## **Proposal for the 05 series of amendments to Regulation No. 100 (Electric power trained vehicles) \***

### **Submitted by the expert from Contracting Parties participated into SIG Thermal Propagation**

The text reproduced below was prepared by the expert from [Australia], France, Germany, Japan, [Republic of Korea], the Netherlands, [the United Kingdom] and the European Commission, aiming for enabling the identification of vehicles approved using certain provision for thermal propagation as well as for proper treatment of intellectual properties of the manufacturers. The proposal is based on the outcome from special interest group on thermal propagation participated by the above Contracting Parties as well as the interested Technical Services, OICA, CLEPA and other entities not a member of these industry organizations. The modifications to the current text of the UN Regulation (including ECE/TRANS/WP.29/2024/41) are marked in bold for new or strikethrough for deleted characters.

**[Figure 3  
Decision flow of verification process**

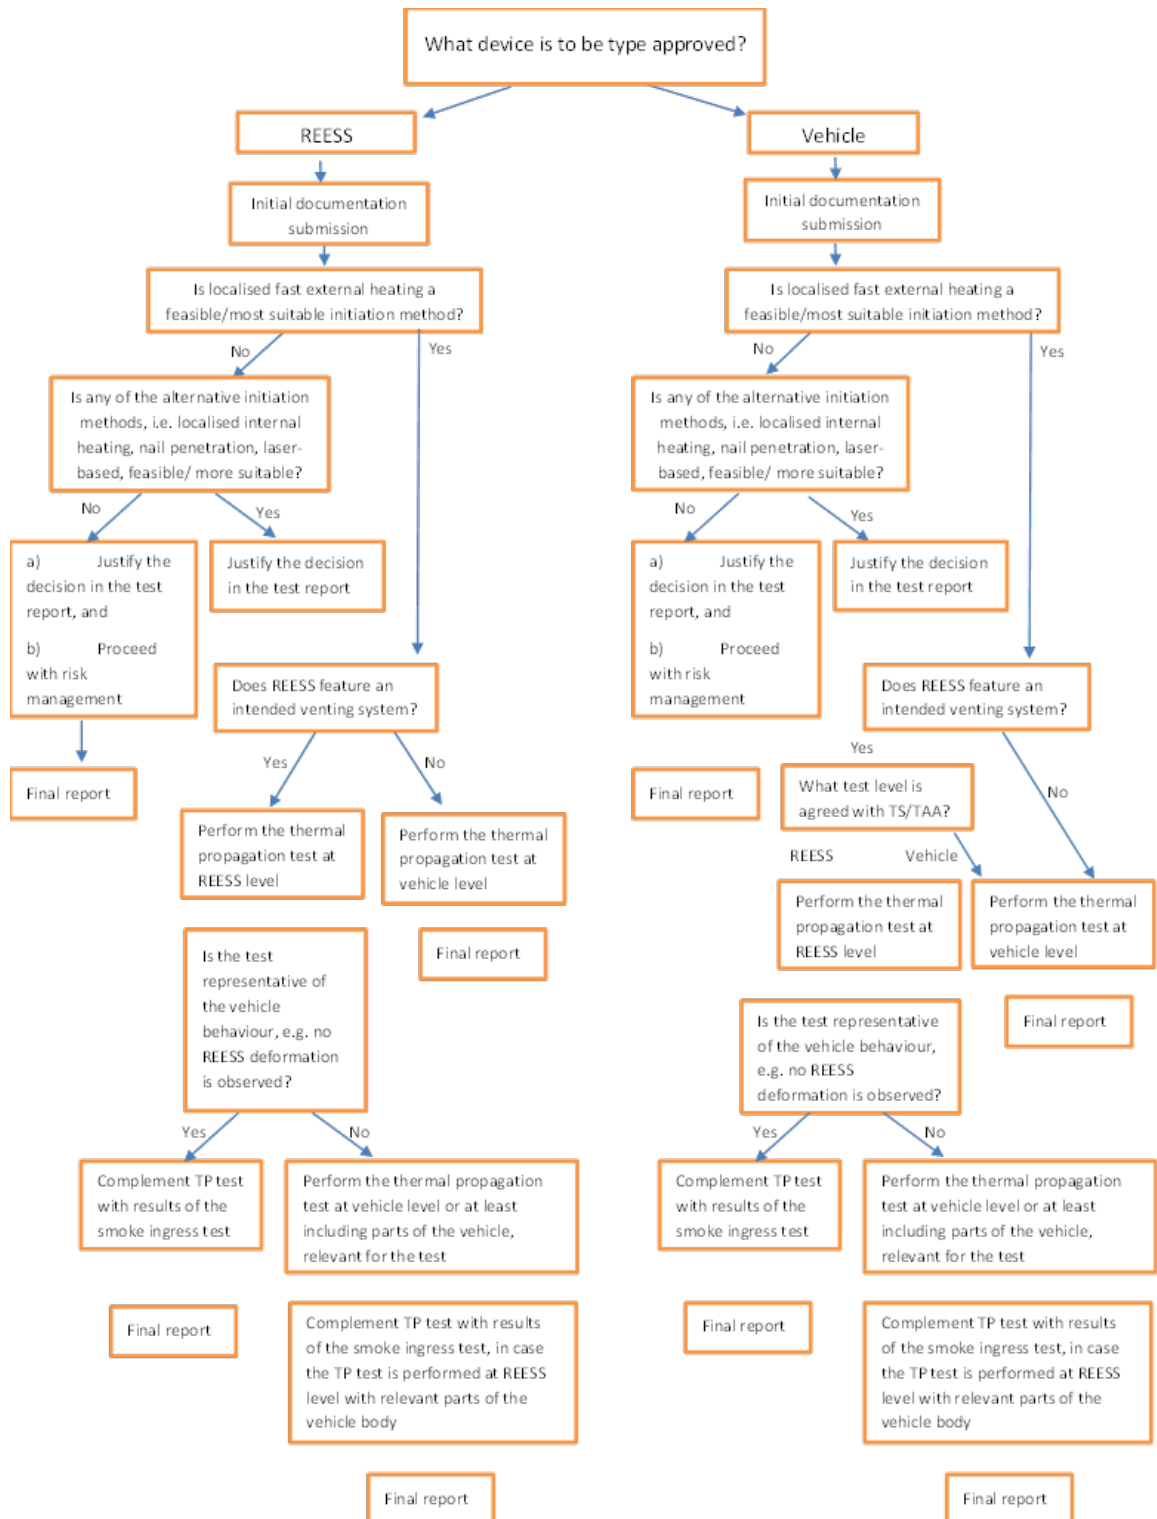
**"6.15.3. The verification process of thermal propagation safety compliance**

**Recognizing that there are different REESS and vehicle designs on the market, and to ensure the technical neutrality of this requirement, the verification of thermal propagation safety compliance process follows a multi-step approach described in paragraphs 6.15.3.1. to 6.15.3.4.**

**Conformance with thermal propagation safety is either demonstrated by physical testing (as described in Annex 9K) or when it is deemed that physical testing is not possible without compromising the REESS safety design, e.g. because REESS design precludes disassembly, by a systematic risk management analysis method (paragraph 6.15.4.). The Type Approval Authority and the Technical Service shall determine, with the help of documentation provided by the manufacturer, whether the physical testing is possible without compromising the safety functionality and design of the vehicle/REESS.**

**If the REESS is designed to be charged only by an energy source on the vehicle [and its capacity in Ah does not exceed the total electric energy of 2 kWh taking into account the working voltage of the REESS], only the risk management analysis according to paragraph 6.15.4. needs to be performed.**

Figure 1

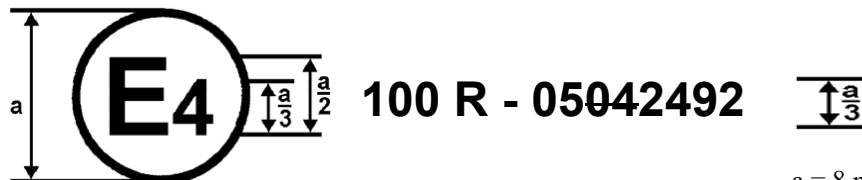
The approval mark in Figure 1 affixed to a vehicle shows that the road vehicle type concerned has been approved in the Netherlands (E 4), pursuant to Regulation No. 100, and under the approval number 04052492. The first two digits of the approval number indicate that the approval was granted in accordance with the requirements of Regulation No. 100 as amended by 0405 series of amendments.
